DEVELOPMENT REVIEW COMMITTEE (DRC) COMMENT REPORT

PROJECT NAME: Florida Community Bank

CASE NUMBER: R18038

REQUEST: Site Plan Level II Review: 2,800 Square Feet of Bank Use within 100 Feet of Residential Property

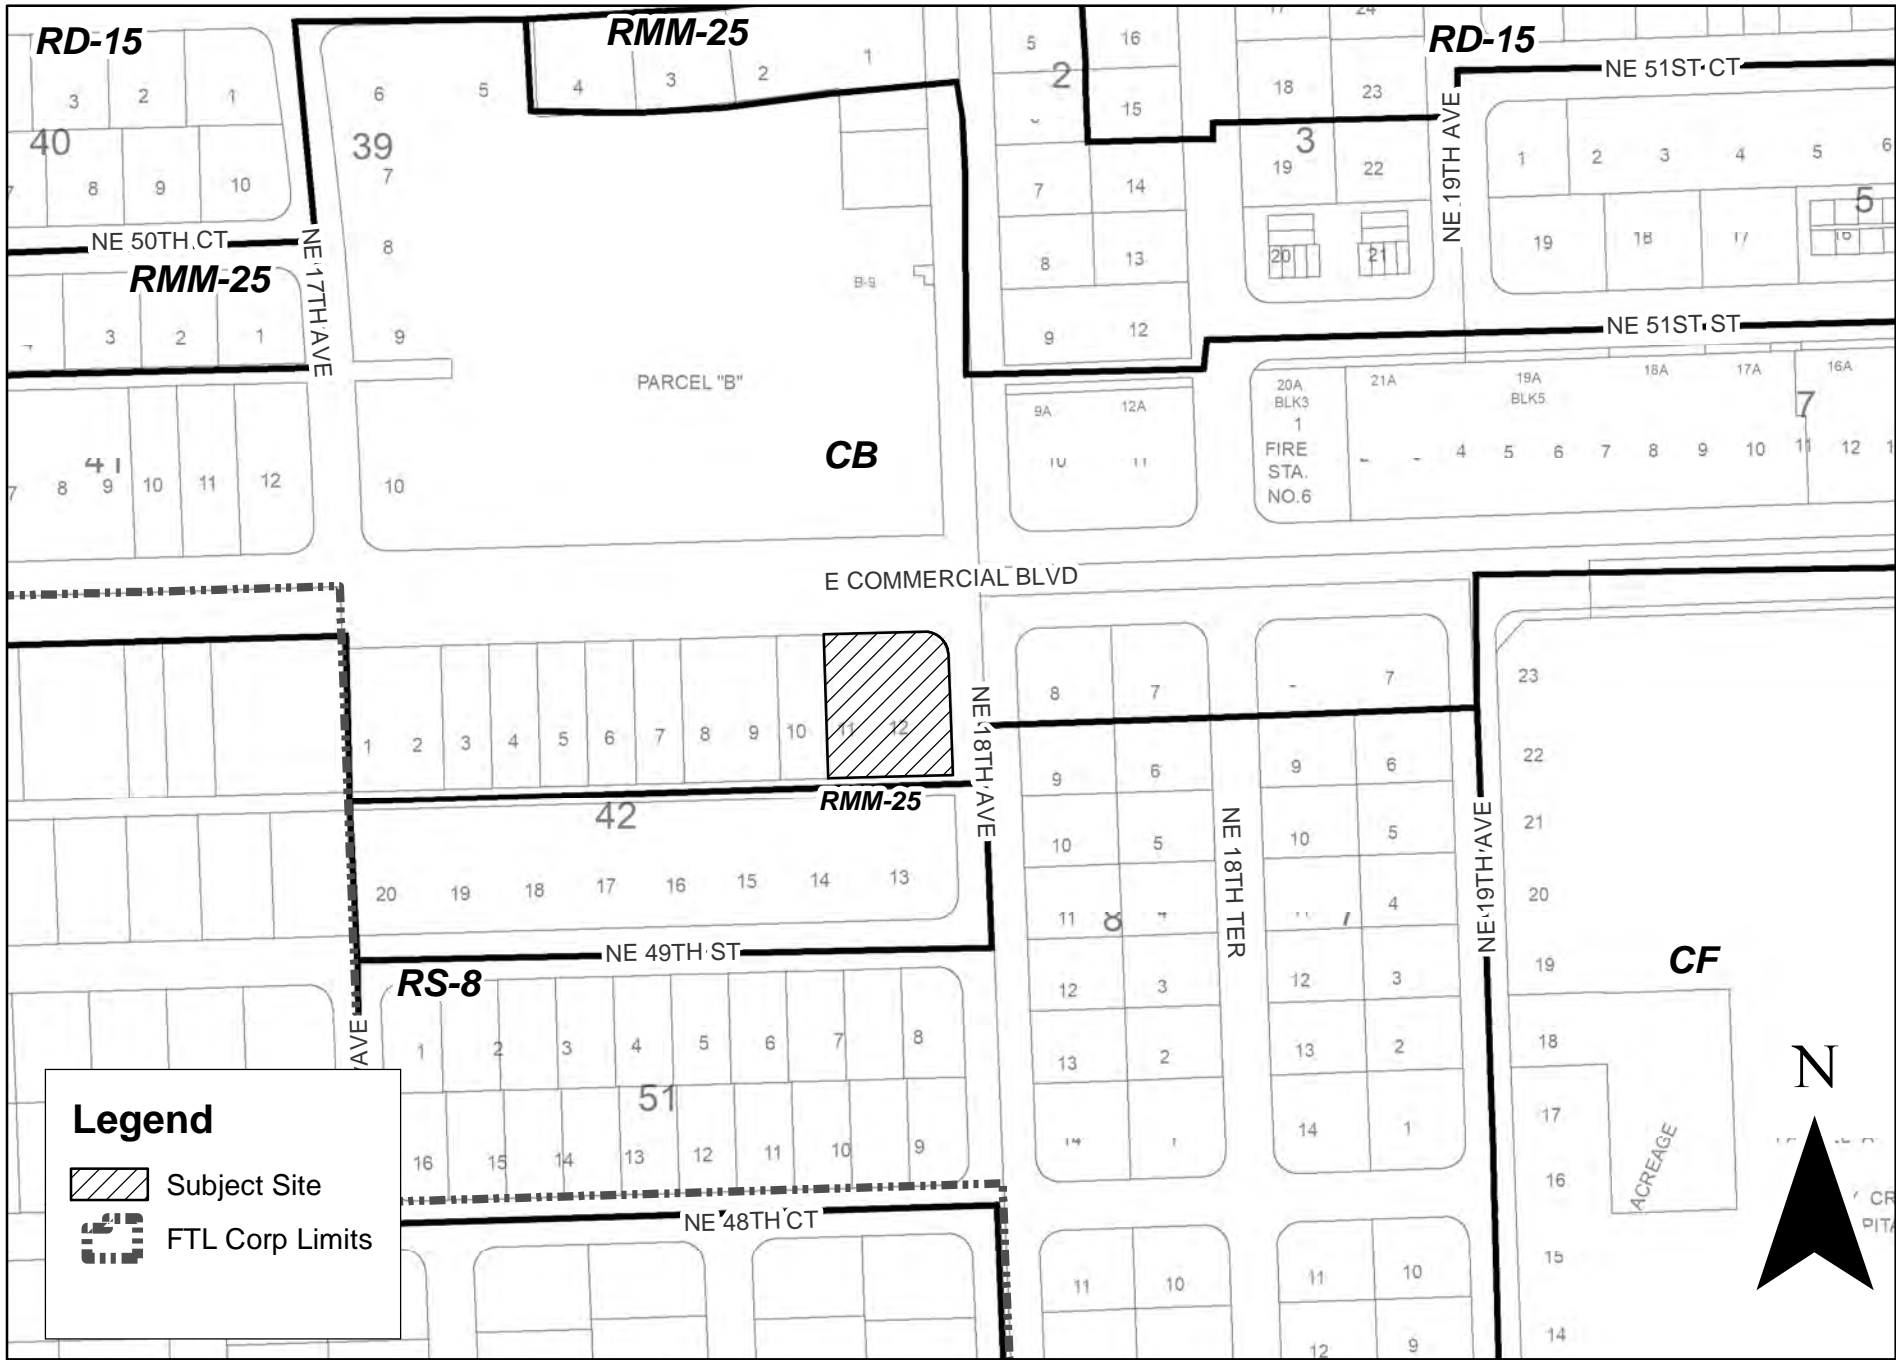
- 10) Move the building closer to the corner of Commercial Boulevard and NE 18th Avenue and re-locate the drive-thru to help activate the street frontage, support pedestrian and multi-modal options and encourage direct access from the sidewalk. Refer to the layout of the Community Bank located at 632 S. Federal Highway (developed by the same owner) as an example. See below site plan:
